REMARKS

VERSION OF AMENDED ITEMS WITH MARKINGS TO SHOW CHANGES MADE

August 29, 2001

FIG. 1A

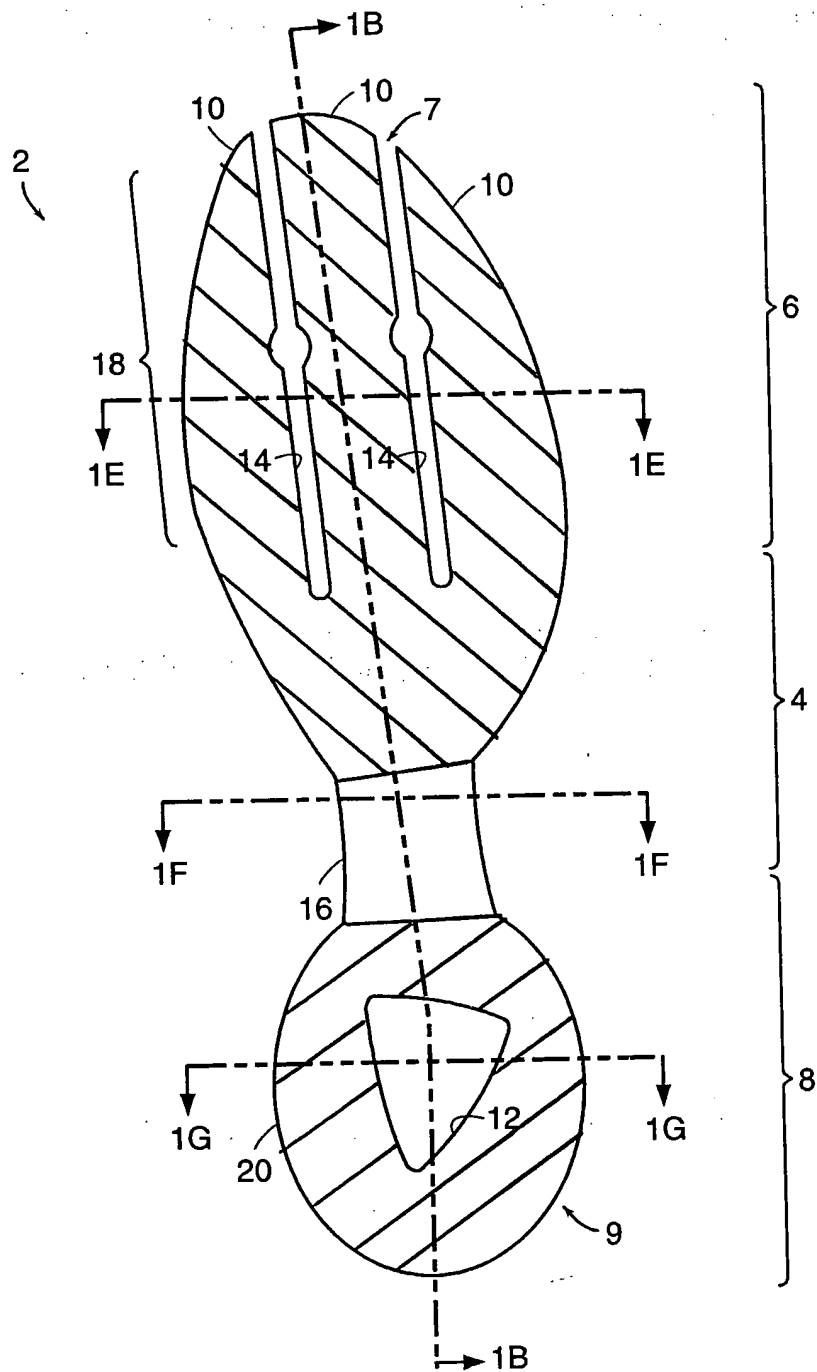
1. Applicant thanks the Examiner for participating in a telephone interview with Applicant's undersigned representative held on August 2, 2001. Applicant respectfully submits that this Amendment and Response is consistent with the discussion therein.
2. The drawings are objected to under 37 C.F.R. § 1.83(a). The Examiner has objected to the drawings stating that they fail to show the following:

- Different thicknesses (as claimed in claims 12-16, and described in the specification at, for example, p. 4, ll. 15-22).
- Different materials (as claimed in claims 17 and 18, and described in the specification at, for example, p. 4, ll. 23-28).
- An intermediate layer (as claimed in claims 32-34 as filed (amended herein to appear as claims 36-38), and described in the specification at, for example, p. 4, ll. 4-10).

The cross-sections depicted in Figures 1B-1G, 2B-2G, and 3B-3G show, by way of example, differing thicknesses as claimed in claims 12-16. Applicant has added shading that is consistent with MPEP § 608.02(m) to Figures 1A, 2A, 3A, and 4 to show the differing materials as claimed in claims 17 and 18. Applicant has amended the specification to describe the shading. Further, Applicant has modified Figures 3B-3G to include an intermediate layer 203 as claimed in claims 32-34 as filed (amended herein to appear as claims 36-38). Applicant has amended the specification to include a description of the new reference designator (203) associated with the intermediate layer. Applicant has also amended the specification to correct a typographical error in referencing figures 3B-3D.

Applicant has amended the drawings per the Examiner's request. To facilitate the Examiner's inspection of the drawings, Applicant has enclosed herewith three sets of professionally redrafted drawings, labeled as follows, with their content as described:

Figures 1A, 2A, and 3A defines, by way of example, areas where the various types of materials may be used.

FIG. 2A

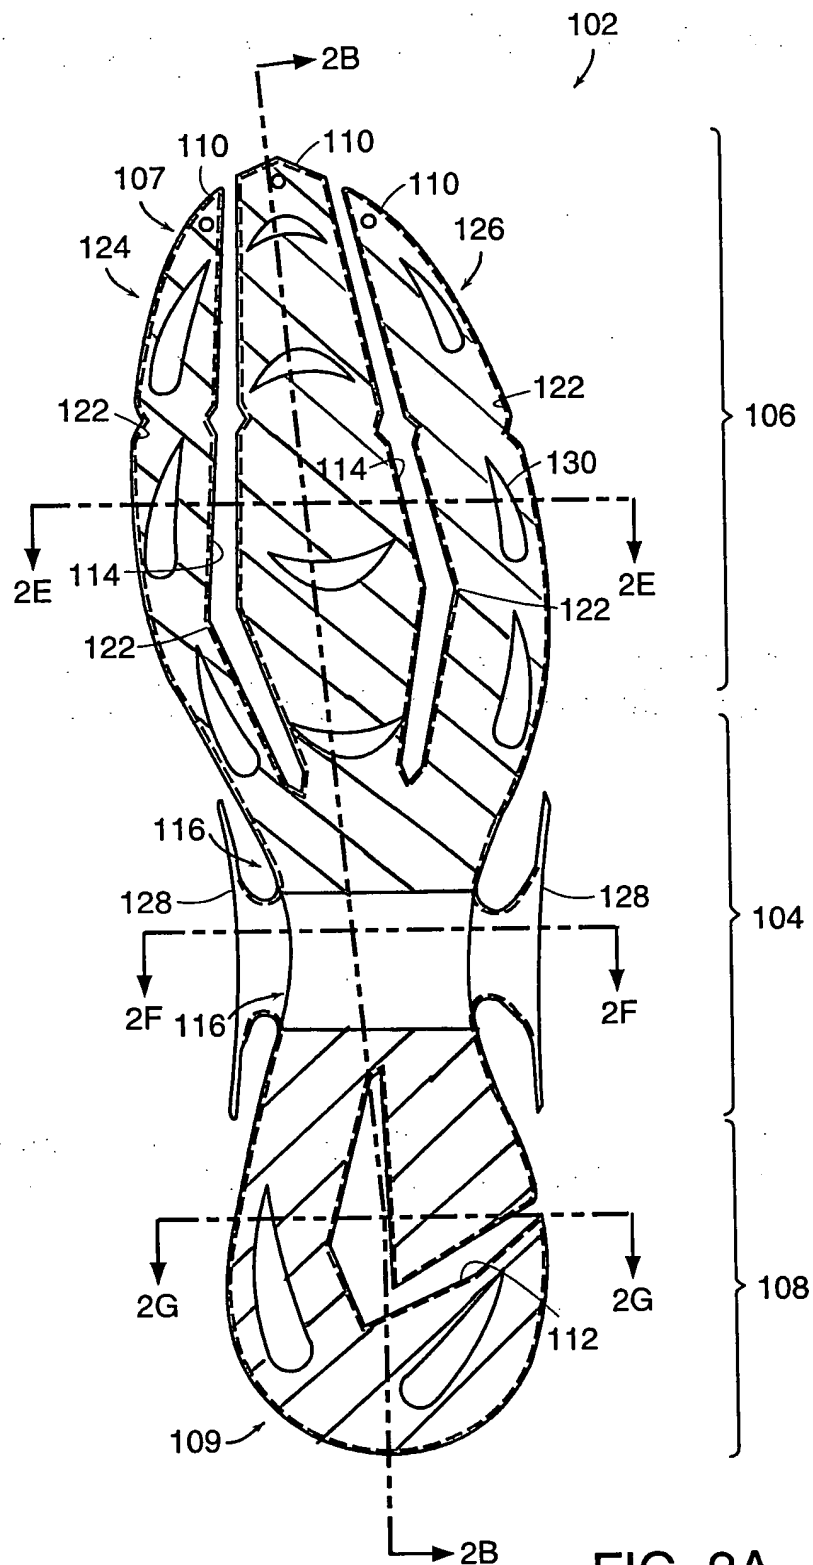
Reference designator 107 appears in Figures 2A through 2D, and reference designator 207 appears in Figure 3A. In comparison, Figure 1A shows another embodiment of the invention where reference designator 7 refers to a toe portion. The specification describes the toe portion 7 at, for example, p. 6, l. 8. Consequently, it is clear that Applicant adopted a common reference designator numbering scheme (i.e., ending in “7,” as in “107” and “207”) to identify the toe region in the various embodiments of the invention. Accordingly, Applicant has amended the specification to associate reference designators 107 and 207 with the toe portion shown in Figures 2A through 2D, and Figure 3A, respectively.

Reference designator 228 appears in Figures 3A, 3C, and 3D. In comparison, Figures 2A, 2C, and 2D show another embodiment of the invention where reference designator 128 refers to side elements. The specification describes the side elements 128 at, for example, p. 8, l. 4. Similar to the above, it is clear that Applicant adopted a common reference designator numbering scheme (i.e., ending in “28,” as in “228”) to identify the side elements in the various embodiments of the invention. Accordingly, Applicant has amended the specification to associate reference designator 228 with the side elements shown in Figures 3A, 3C, and 3D.

The Office Action further states that in claim 5 the phrase “a fold line” is vague and indefinite. Fold lines 122, 222 appear in Figures 2A and 3A. As detailed in the specification at p. 8, ll. 11-12 and p. 10, ll. 23-24, the fold lines 122, 222 are essentially indentations that facilitate bending in certain areas of the chassis 102 and chassis/skin 201. As discussed with, and endorsed by, the Examiner, Applicant has amended claim 5 to replace the term “fold line” with “indentation.” Applicant respectfully submits that claim 5, as amended herein, is sufficiently clear and definite and is therefore allowable.

Fig. 2A depicts a bottom plan view of another embodiment of the chassis 102 of the present invention. In this embodiment, a forefoot portion 106 and a rearfoot portion 108 extend into a toe portion 107 and a heel portion 109, respectively. In this embodiment of the chassis 102, the finger-shaped elements 110 in the forefoot portion 106 have fold lines 122 as well as spaces 114 therebetween. The fold lines 122 and spaces 114 of the finger-shaped elements allow for greater flexibility in the forefoot region 106. In the process of walking or running, the forefoot region 106 of a wearer bends as he shifts his weight from his heel to his forefoot and then pushes off with the forefoot. These finger-shaped elements 110 and spaces therebetween 114 allow for greater and easier bending in this region.

FIG. 3A

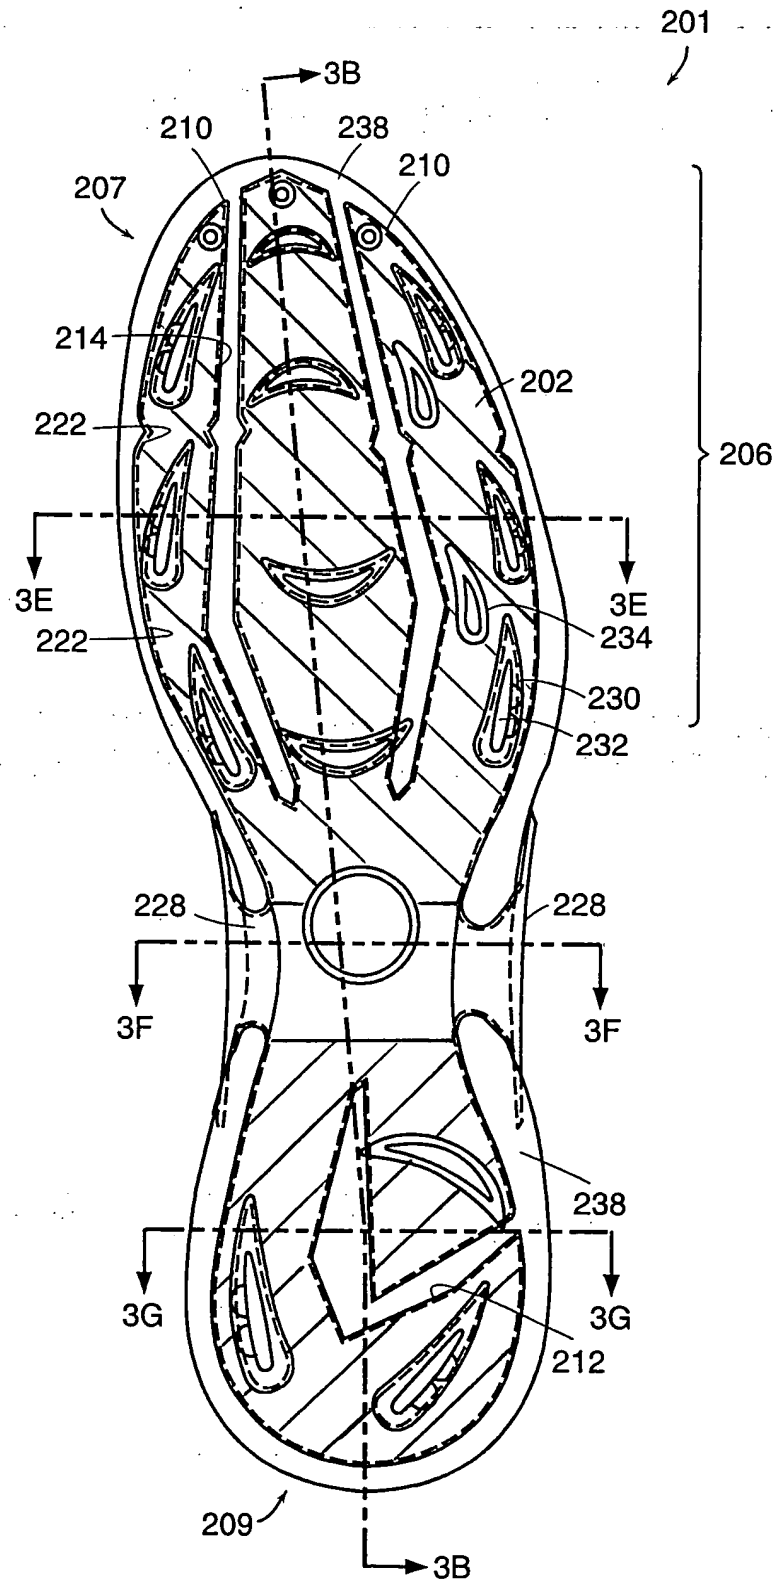
With respect to Figure 3A, Applicant has added the inadvertently omitted reference designator 206 identifying the forefoot region. No new matter has been added, since "forefoot region 206" is described in the specification as filed at, for example, p. 10, l. 24.

Fig. 3A shows a plan view of the bottom side of the chassis/skin 201. The finger-shaped elements 210 in the forefoot region 206 have fold

lines 222 to facilitate flexing at these regions. The forefoot region 206 includes a toe portion 207. The opening 212 in the heel portion 209 is in the shape of a chevron. Figs. 3B-3C-3D show a cross-sectional view along section 3B-3B, a medial side view, and a lateral side view, respectively, of the chassis/skin construct 201. Figs. 3E-3G show cross-sectional views along sections 3E-3E, 3F-3F, and 3G-3G of the chassis/skin construct 201. Figs. 3H-3I show end views of a toe view and a heel view, respectively.
